World Forum for Harmonization of Vehicle Regulations**Working Party on Brakes and Running Gear****Eightieth session**

Regulation No. 55 (Mechanical couplings)**Proposal for Supplement 5 to the 01 series of amendments to
Regulation No. 55 (Mechanical couplings)****Submitted by the Chair of the informal group on Regulation No. 55***

The text reproduced below was prepared by the informal group of experts on Regulation No. 55 to introduce amendments on the test procedure and installation of couplings belonging to class K and L. The modifications to the current text of the Regulation are marked in bold for new or strikethrough for deleted characters.

Figure 25 a

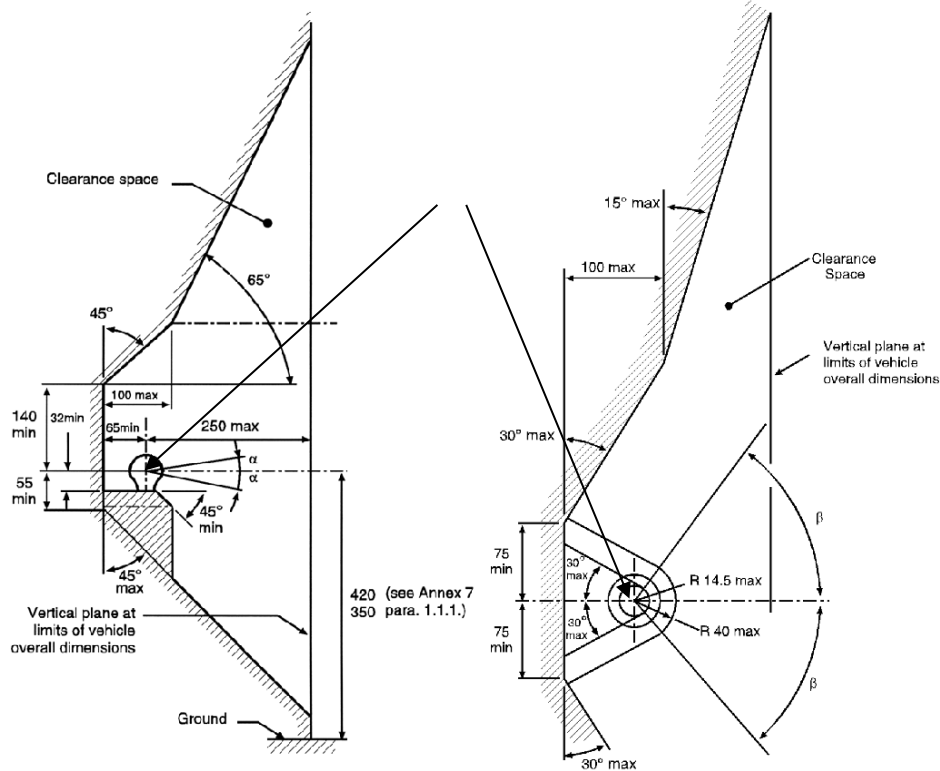
- 1.1.1.1. The clearance space shown in Figures 25a and 25b may be occupied by non-demountable equipment, such as a spare wheel, provided that the distance from the **centre** of the ball **or the centre of the hook** on a vertical plane at the extreme rearmost point of the equipment does not exceed ~~300 mm~~/**250 mm** The equipment shall be mounted to allow adequate access for coupling and uncoupling without risk of injury to the user and without affecting articulation of the coupling.

- 1.1.3. It shall be possible to couple and uncouple ball couplings/**hook coupling** when the longitudinal axis of the ball coupling/**hook coupling** in relation to the center line of the coupling ball/**hook coupling** and mounting:

- is rotated horizontally 60° to right or left, ($\beta = 60^\circ$, see Figure 25);
- is rotated vertically 10° up or down ($\alpha = 10^\circ$, see Figure 25);

1.2.2. It shall be possible to operate the coupling heads/ **toroidal drawbar eyes** safely within the free space of the coupling ball/**hook coupling** given in figures 25a and 25b, up to angles of $a = 25^\circ$ and $b = 60^\circ$.
